APPLICATION NO.	FILING DATE	FIRST NAMED INVENTOR	ATTORNEY DOCKET NO.	CONFIRMATION NO.
10/710,401	07/08/2004	Min-Lung Huang	11571-US-PA	4400
31561	7590	05/04/2005	EXAMINER	
JIANQ CHYUN INTELLECTUAL PROPERTY OFFICE 7 FLOOR-1, NO. 100 ROOSEVELT ROAD, SECTION 2 TAIPEI, 100 TAIWAN			CHU, CHRIS C	
			ART UNIT	PAPER NUMBER
			2815	
DATE MAILED: 05/04/2005

<b>Office Action Summary</b>	<b>Application No.</b>		<b>Applicant(s)</b>	
	10/710,401		HUANG, MIN-LUNG	
	<b>Examiner</b>		<b>Art Unit</b>	
	Chris C. Chu		2815

## **DETAILED ACTION**

***FIG. 9***

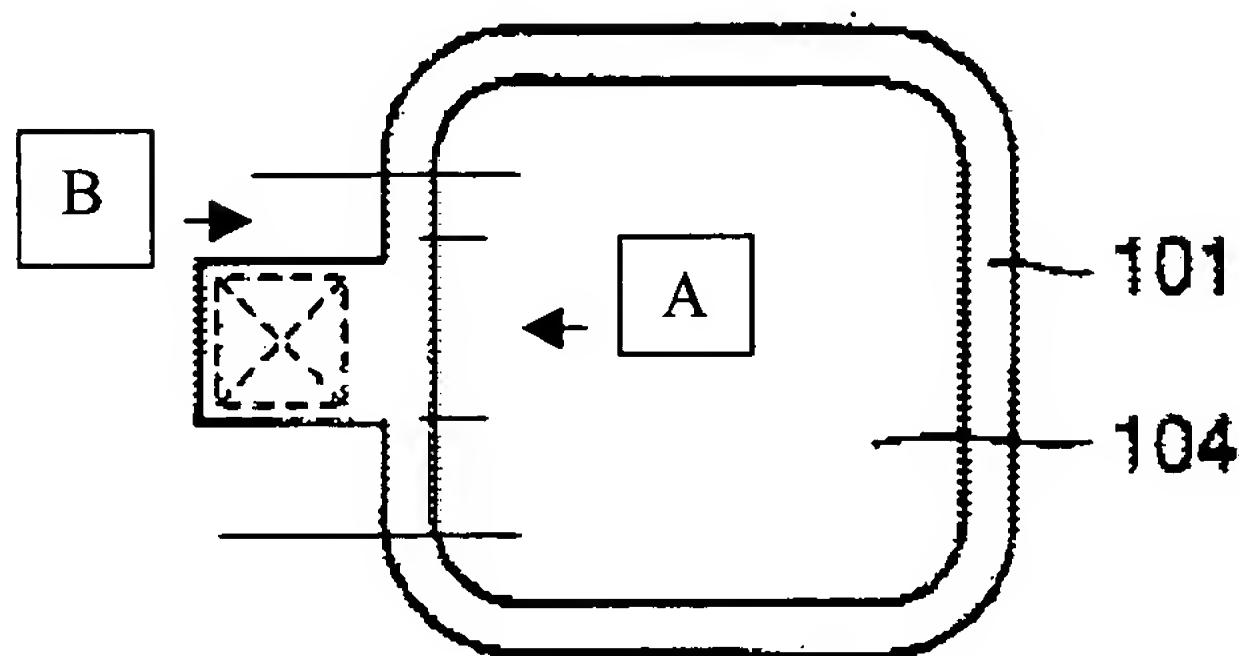
Regarding claim 1, Harada et al. discloses in e.g., Fig. 3 and Fig. 9 a chip structure, at least comprising:

- a chip (structure in e.g., Fig. 1B), having at least a bonding pad (101; column 18, line 23) and a transmission line (100; column 18, line 19) on a chip surface,

- wherein the transmission line (100) is coupled to the bonding pad; and
- a passivation layer (102 and 103; column 18, line 63 – column 19, line 4), covering the chip surface,
- wherein the passivation (102 and 103) has an opening (104; column 19, line 4) to expose the bonding pad (101),

- wherein a cross-section of the opening (104) includes
  - o a straight line (A or B in Fig. 9) and an arc (the other portion except the “A” or “B” portion. Since the definition of “arc” includes a continuous portion of a curved line, the other portion except the “A” or “B” area read as an “arc”) connecting to two ends of the straight line, and
  - o the straight line is near to a connection terminal between the transmission line and the bonding pad (see e.g., Fig. 9).

Regarding claim 2, since the length of the straight line (A) is smaller than the half of the total length of the opening 104, the straight line of Harada et al. fully meets the claimed limitation.

Regarding claim 3, since the length of the straight line (B) is bigger than the half of the total length of the opening 104, the straight line of Harada et al. fully meets the claimed limitation.

Regarding claims 4 and 10, Harada et al. discloses in e.g., Fig. 9 the passivation layer (102 and 103) including an organic passivation layer (polyimide; column 19, lines 1 – 4).

**FIG.50**

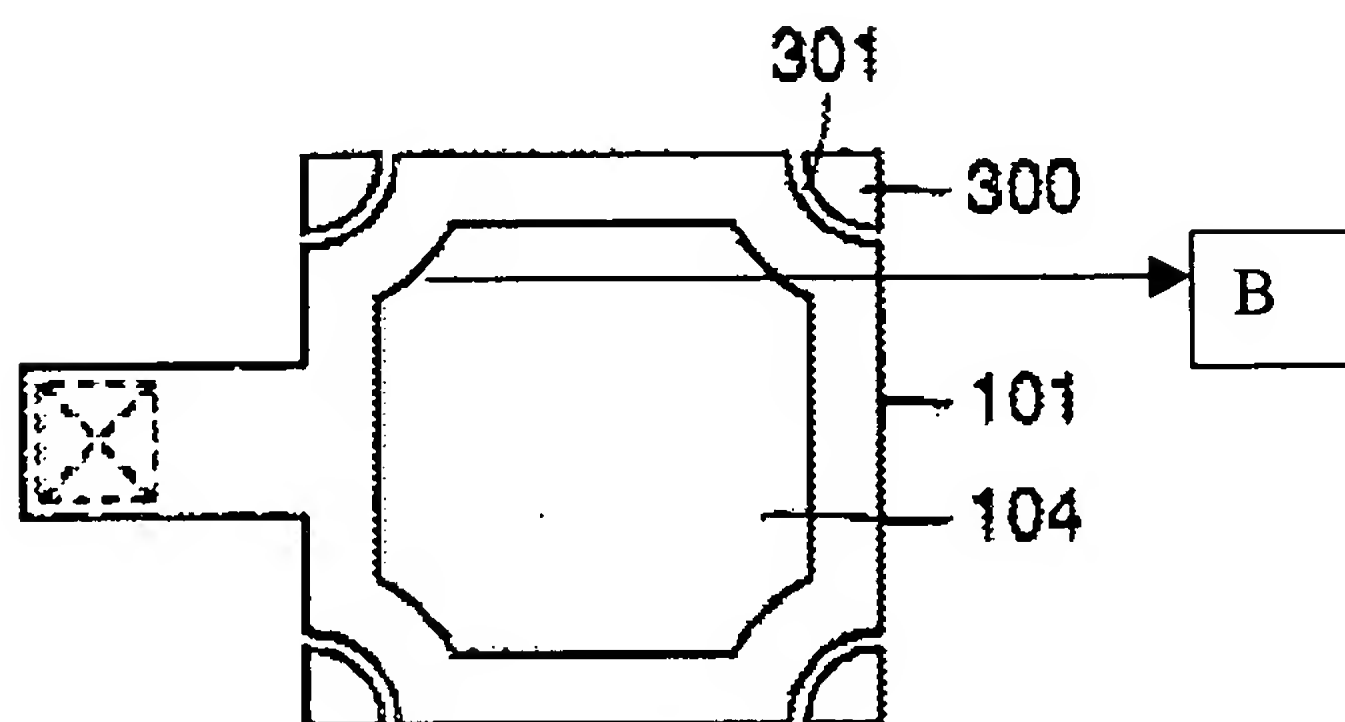
Regarding claim 6, Harada et al. discloses in e.g., Fig. 3 and Fig. 50 a chip structure, at least comprising:

- a chip (structure in e.g., Fig. 1B), having at least a bonding pad (101; column 18, line 23) and a transmission line (100; column 18, line 19) coupled to the bonding pad,

- wherein the bonding pad (101) and the transmission line (100) are on a chip surface;  
and
- a passivation layer (102 and 103), covering the chip surface,
- wherein the passivation (102 and 103) has an opening (104) to expose the bonding pad (101),
- wherein a cross section of the opening (104) includes
  - o a curving line (B in Fig. 50) and an arc (any other curved portion except the “B” portion) connecting to two ends of the curving line,

- o wherein the curving line is concave to the arc and near to a connection terminal (105; see Fig. 4) between the transmission line (100) and the bonding pad (see e.g., Fig. 50).

Regarding claim 7, Harada et al. discloses in e.g., Fig. 50 each point of the curving line has a “substantially” equal distance to the connection terminal between the transmission line and the bonding pad.

Regarding claim 8, Harada et al. discloses in e.g., Fig. 50 a curvature of the curving line being less than or equal to a curvature of the arc.

Regarding claim 9, Harada et al. discloses in e.g., Fig. 50 a curvature of the curving line being greater than or equal to a curvature of the arc.
